NAPA 3217, 3231, and 3232 Product Construction Updates

CONSTRUCTION UPDATE

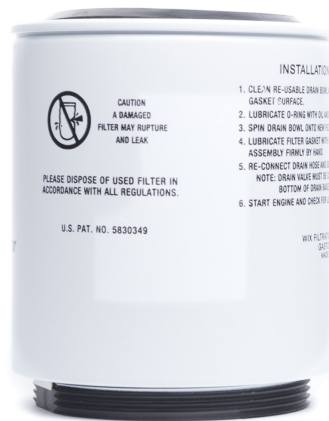
Construction updates have been made to these filters resulting in notable appearance changes. The inside/out flow pattern of the previous design used an open endcap. The update design has an outside/in flow pattern and uses a closed endcap.

The bottom endcaps of the previous (left) and updated (right) designs are pictured. The installation instructions have also been updated to include international markings (right, above).

This change is part of an ongoing commitment for product improvement. Though the designs appear different, the previous and new versions are fully interchangeable and suitable for use on all recommended applications.
